WILLIAMSON COUNTY, TEXAS

CHANGE ORDER NUMBER: 2

Project Name: Corridor C-SH 29 Bypass

Corridor C- SH29 Bypass Williamson County Project No. 23IFB67 Change Order No. 2

JONAH WATER S.U.D.
WILLIAMSON COUNTY, TEXAS
2020 - SH 29; CORRIDOR "C", UTILITY ADJUSTMENTS
SERVICE RECONNECTION

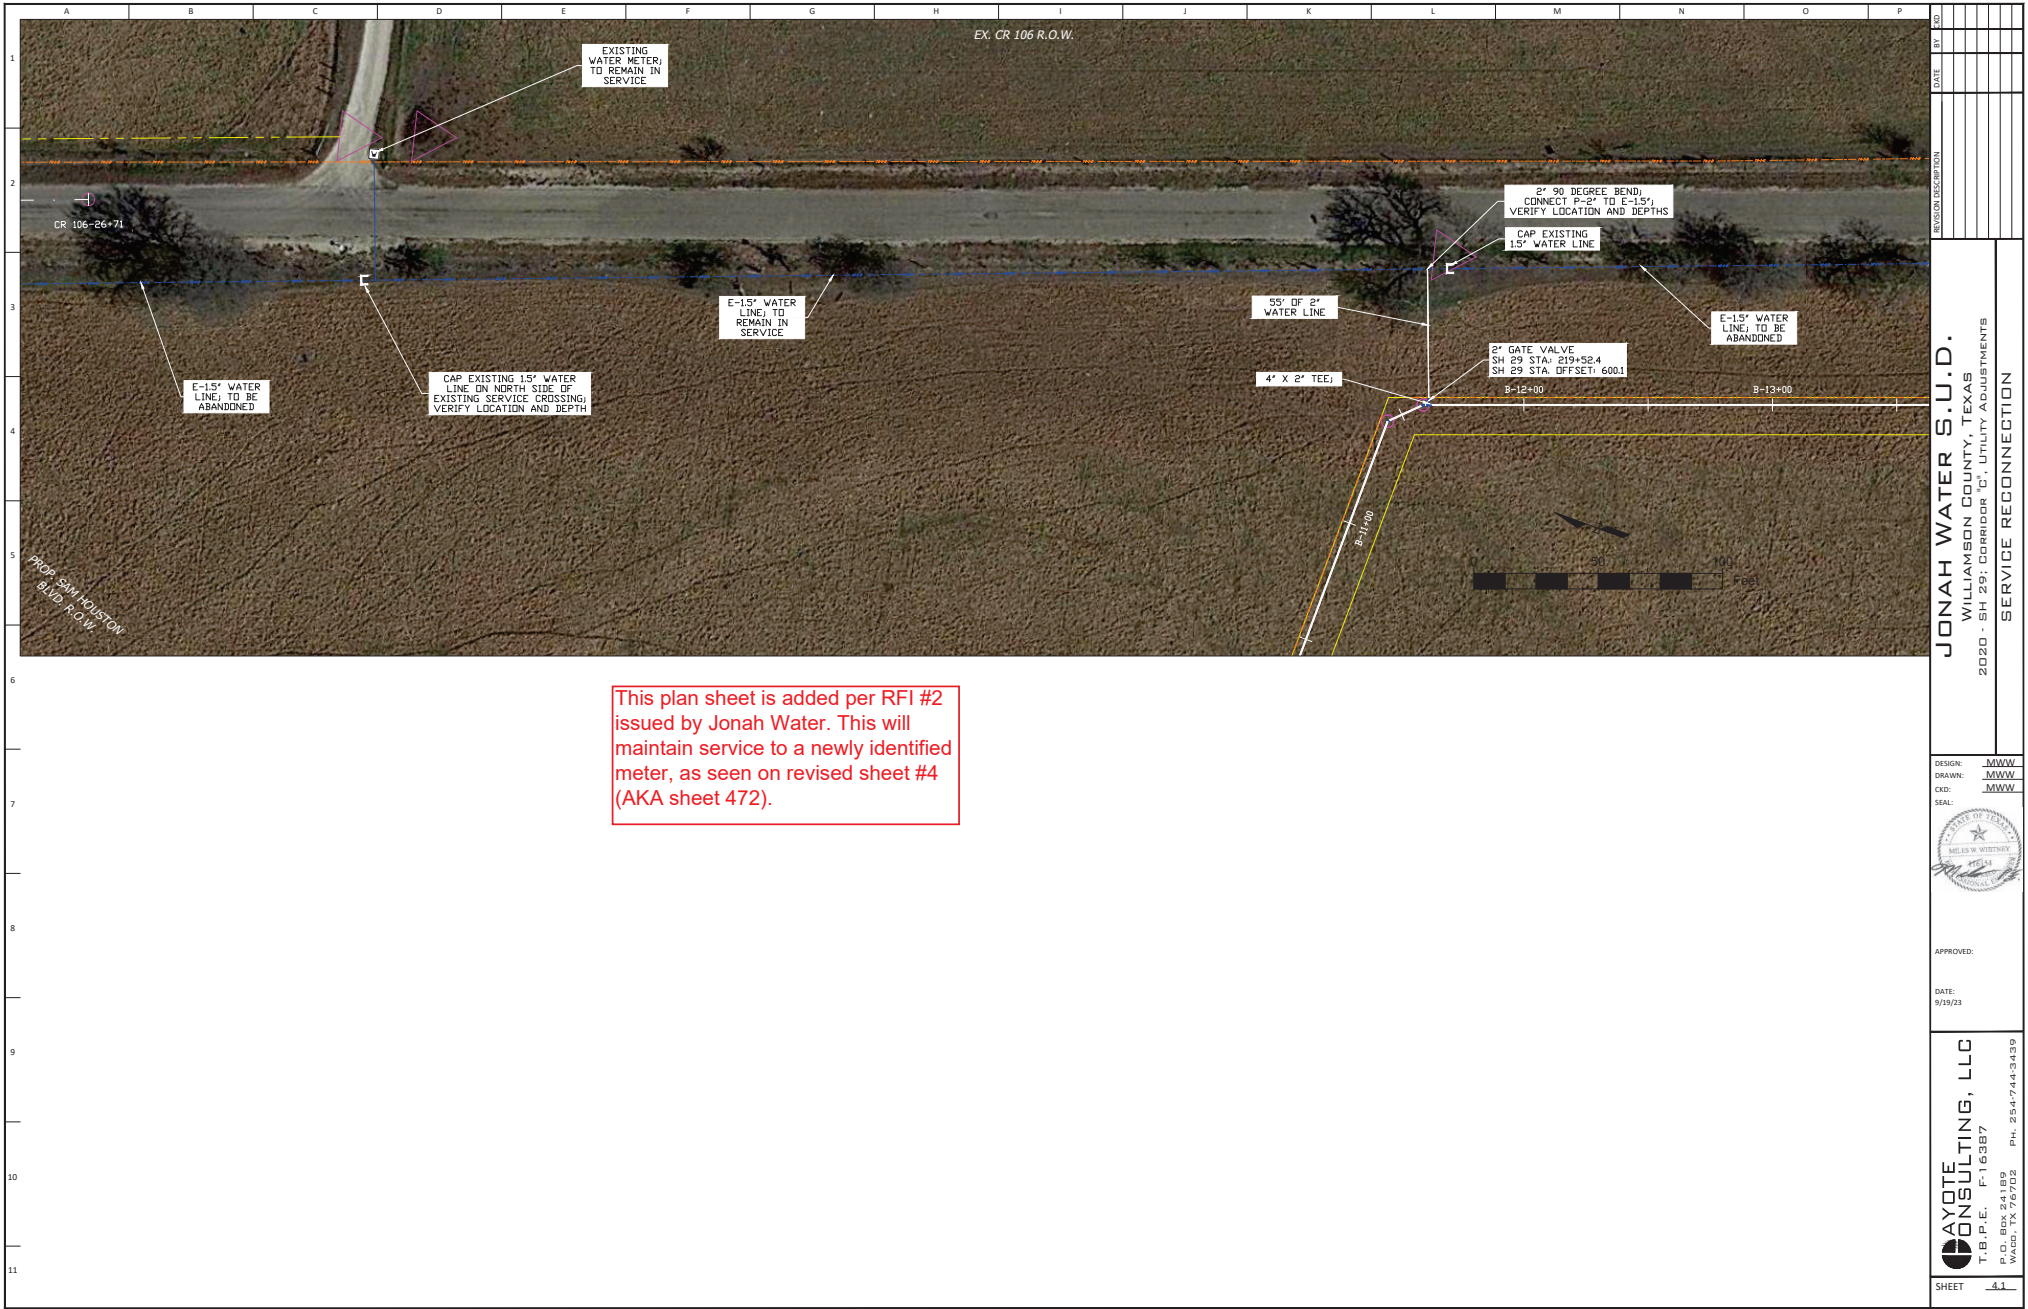
Jonah's staff have identified an existing meter, that was not acknowledged in the current plan set.

Jonah's staff have identified an existing meter, that was not acknowledged on the current plans set. Please see the revised and add plan sheet 4 and the added plan sheet 4.1 to the project plans, to maintain service to this existing meter.

This plan sheet is added per RFI #2 issued by Jonah Water. This will maintain service to a newly identified meter, as seen on revised sheet #4 (AKA sheet 472).

See the revised sheet #4 and the added plan sheet 4.1 to the project plans, to maintain service to this existing meter.

Sheets				
Column1	Column2	Column10	Column11	Column19	Column20	Column21
Item No.	Item Description	4	4.1	Revised Project Totals	Original Project Qty.	Δ
4.1	2" C-900, DR-18 PVC Pipe; w/ Tracer Wire; Installed		55	55	0	55
11.1	2" Gate Valve, Box, and Marker; Installed		1	1	0	1
15.1	Connect Existing 1.5" to New 2"; Installed		1	1	0	1
19	Cap Existing 1.5" Waterline; Installed	1	2	4	2	2
22	Trench Safety	732	55	2,803	2748	55
